TMI-1

Three Mile Island Nuclear Station  
Procedure Change Request

PCR No. 1-MD-93-0075

1. Procedure EP1004.7 REG OFFSITE/ONSITE DOSE PROJECTIONS  
No Present Revision No Title

B. DTSG Tube Rupture Leakrate

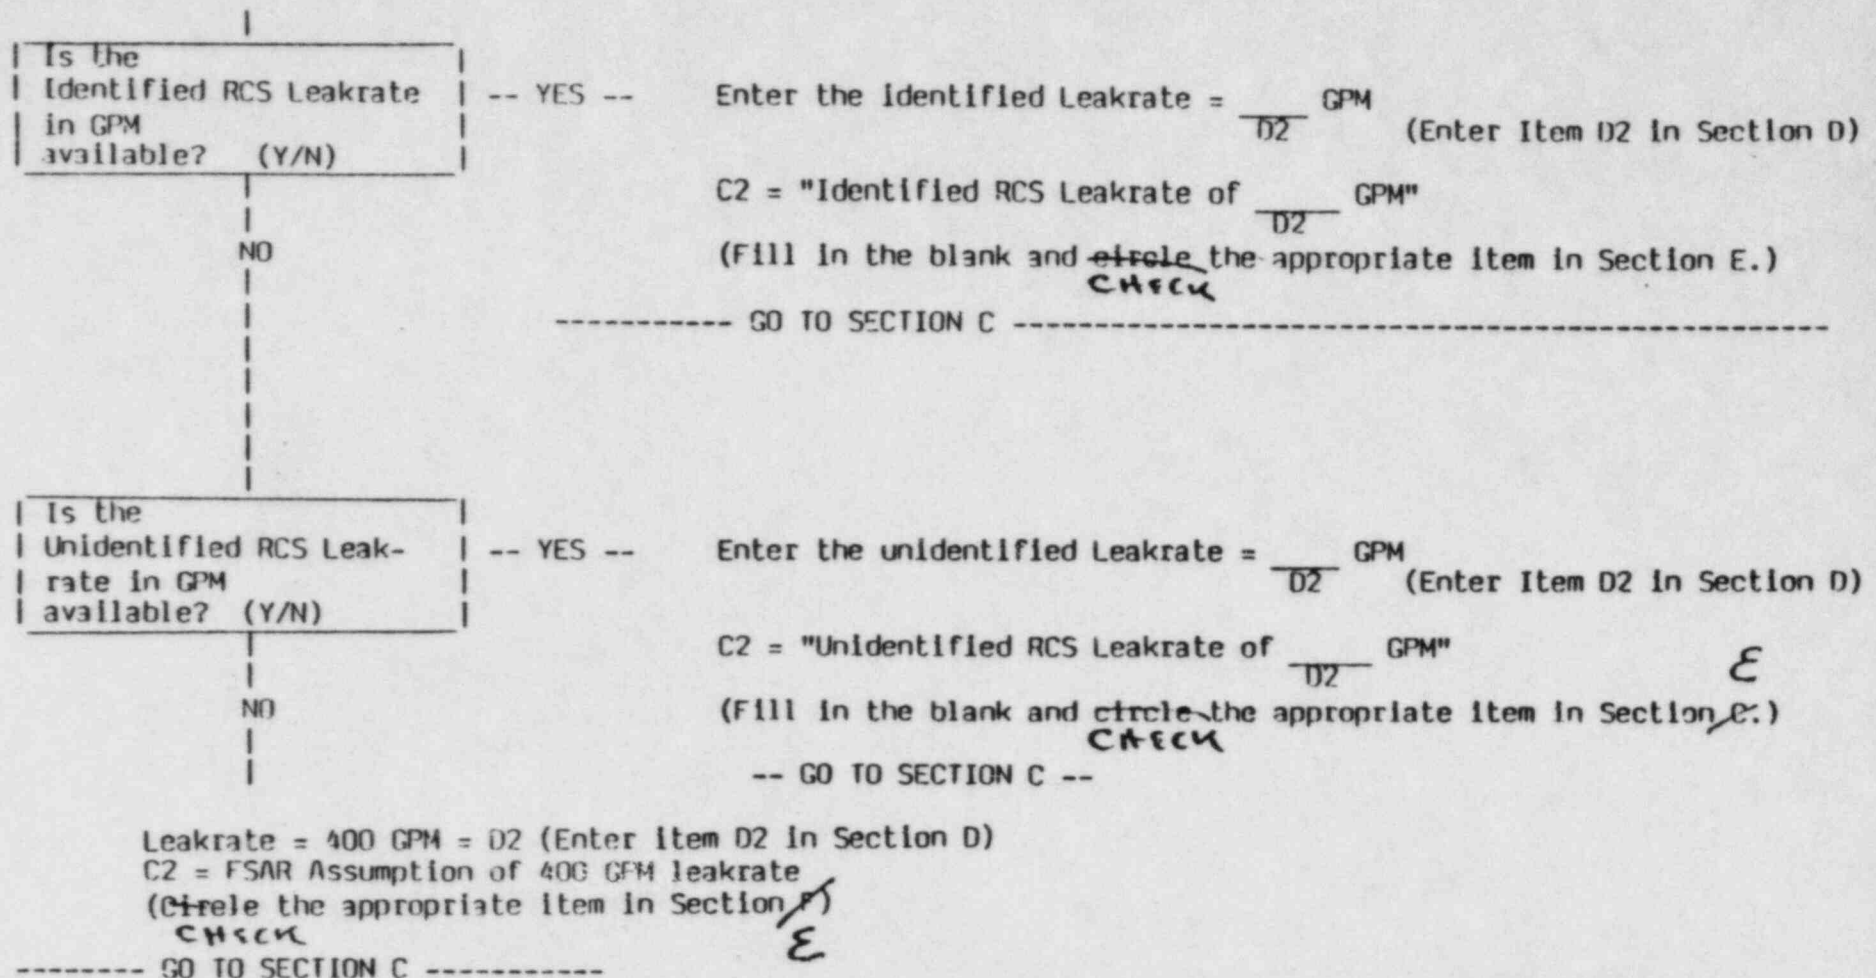
CASE 1: SECONDARY SIDE RELEASE

A. Accident Selection

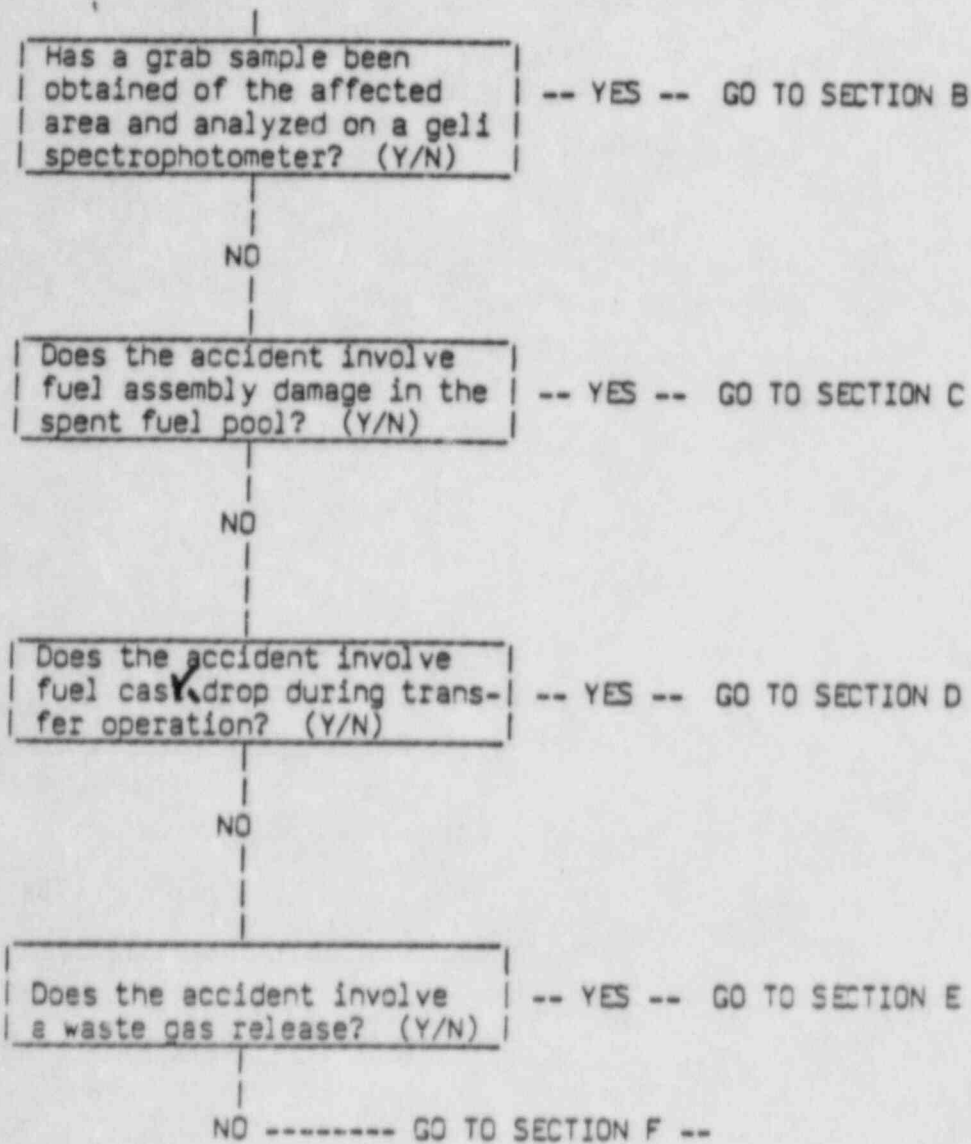
CASE III: AUXILIARY AND FUEL HANDLING BUILDING RELEASE
